December 3, 2021

**RE: International District Library**  
**7667 Central Ave. NE**  
**Permanent C.O. - Approved**  
**Engineer's Certification Date: 11/30/21**  
**Engineer's Stamp Date: 12/11/19**  
**Hydrology File: K19D005**

SHEET TITLE GRADING PLAN	
DESIGN PHASE 100% CONSTRUCTION DOCUMENTS 11 DECEMBER, 2019	
SHEET NUMBER C101

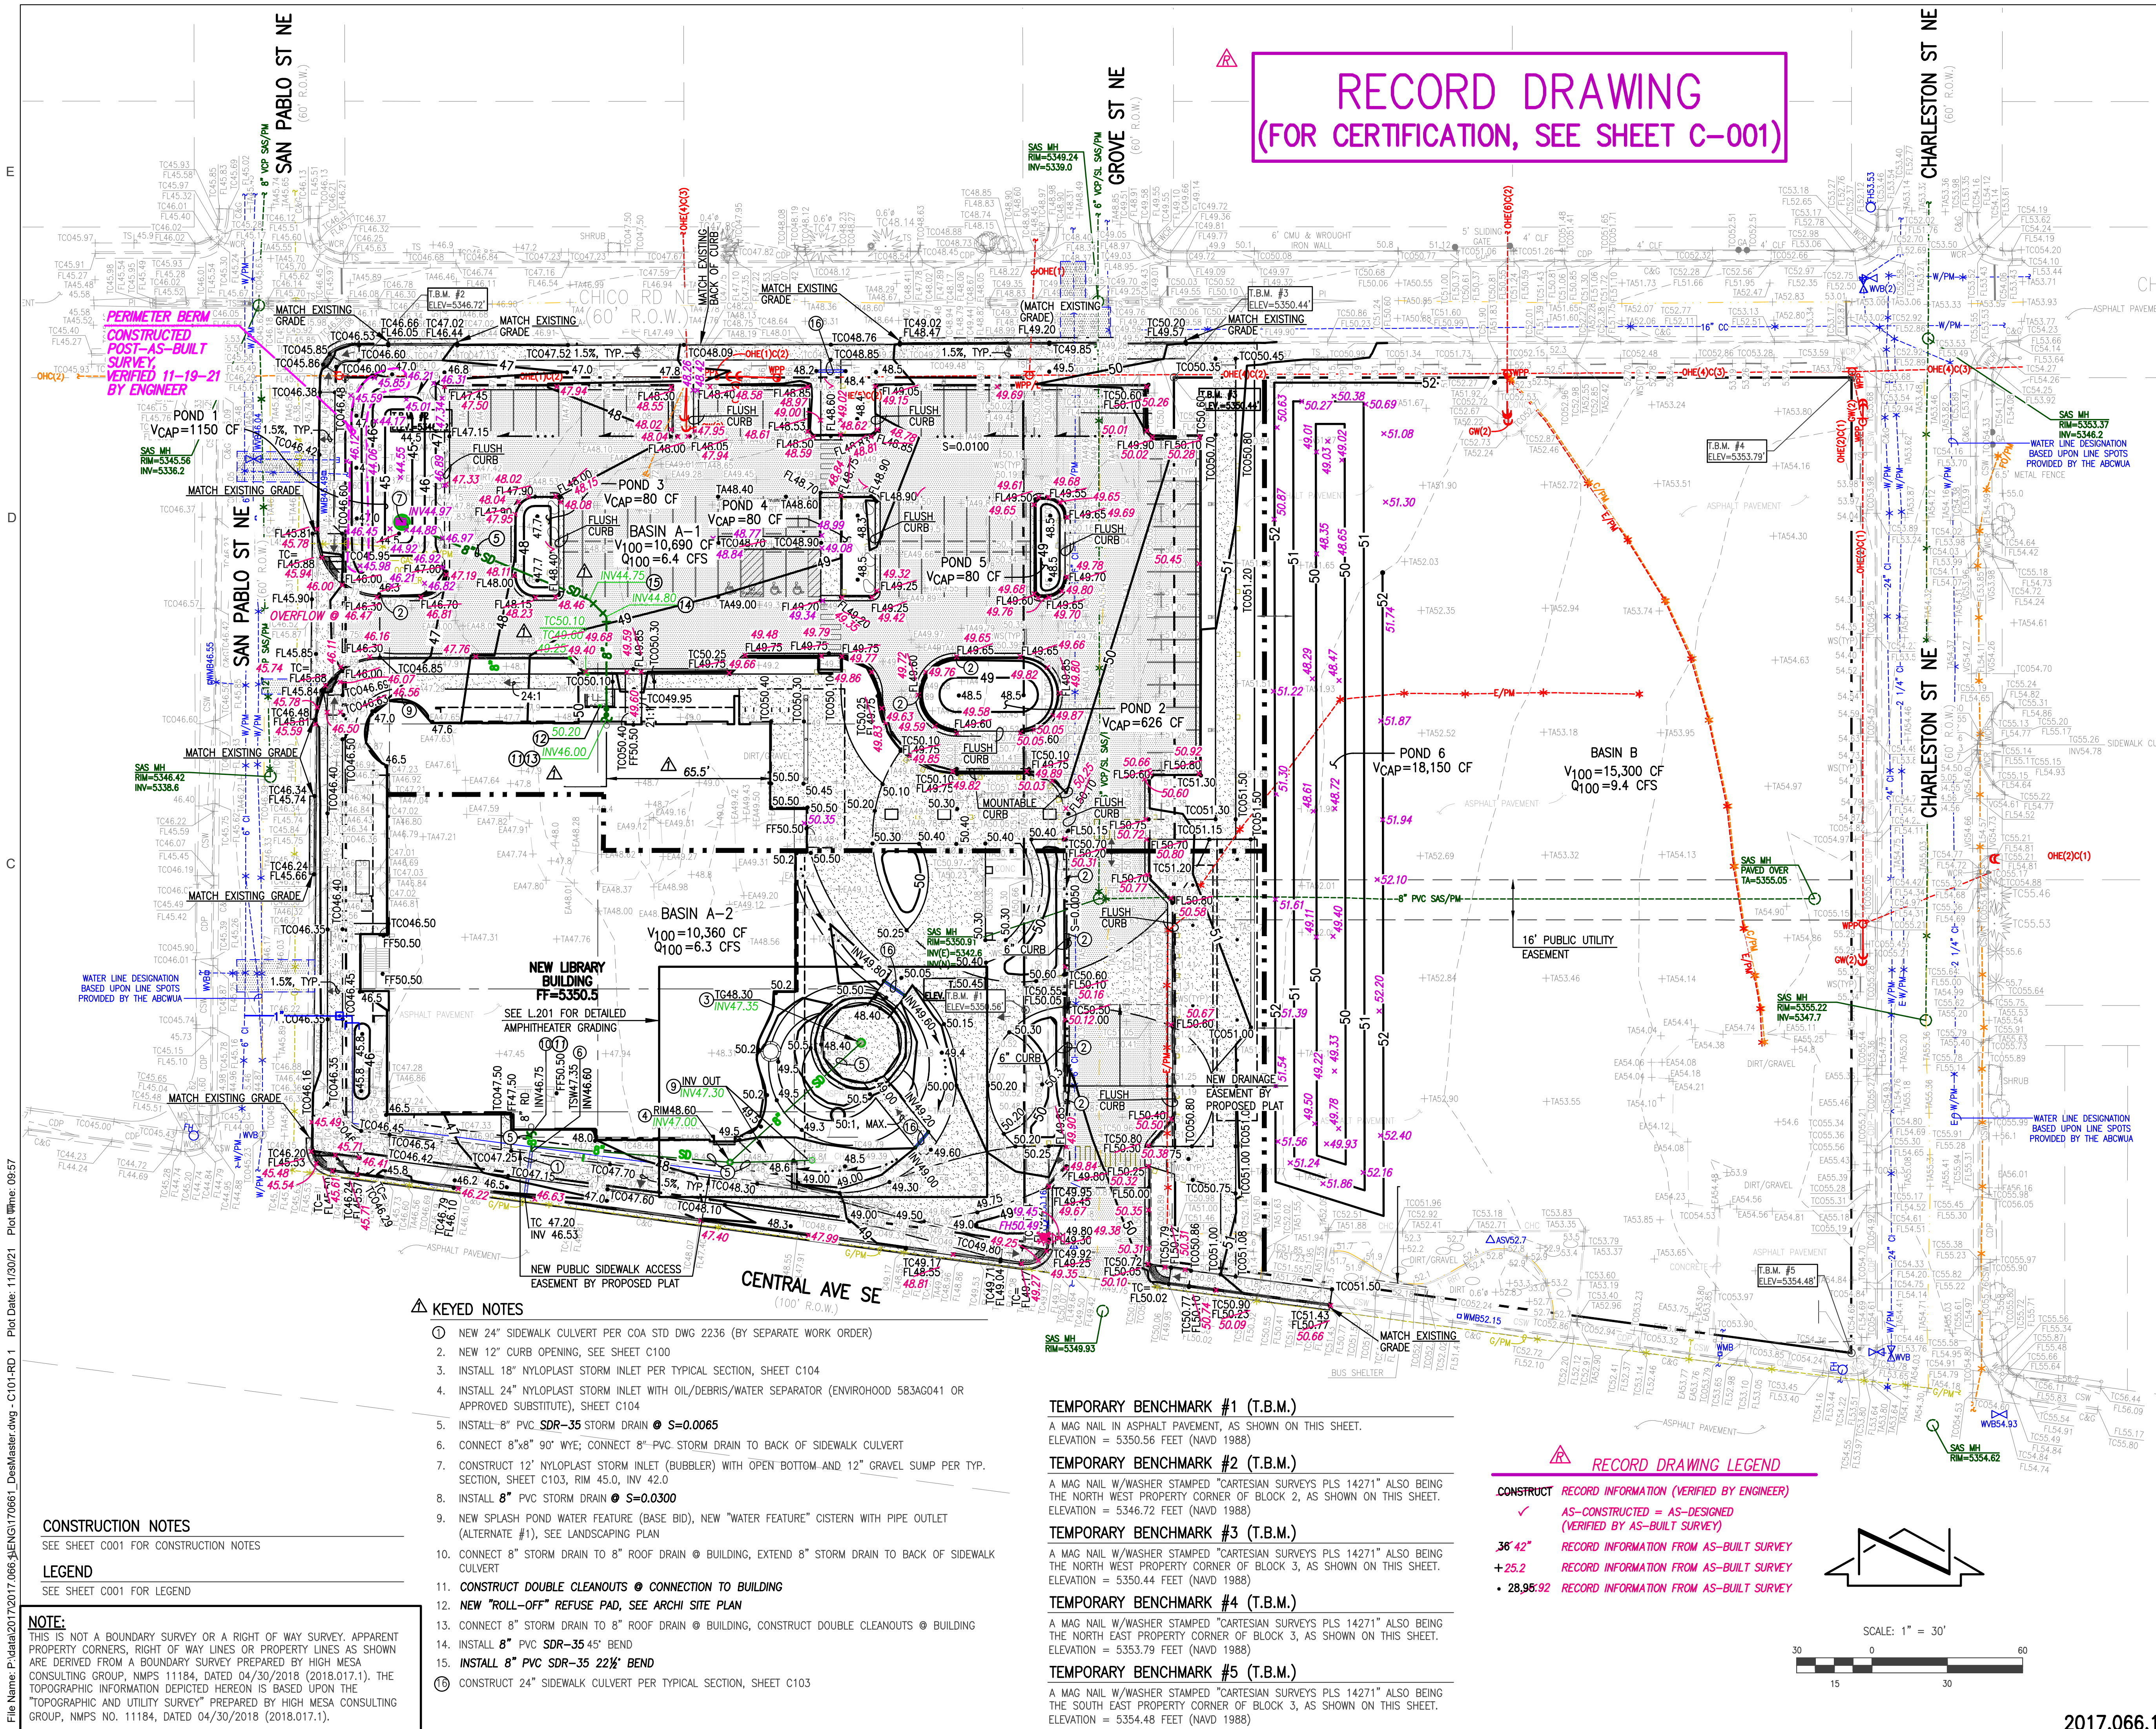
Please have your contractor clean up the site. There is currently a large dirt pile just south of Pond 6.
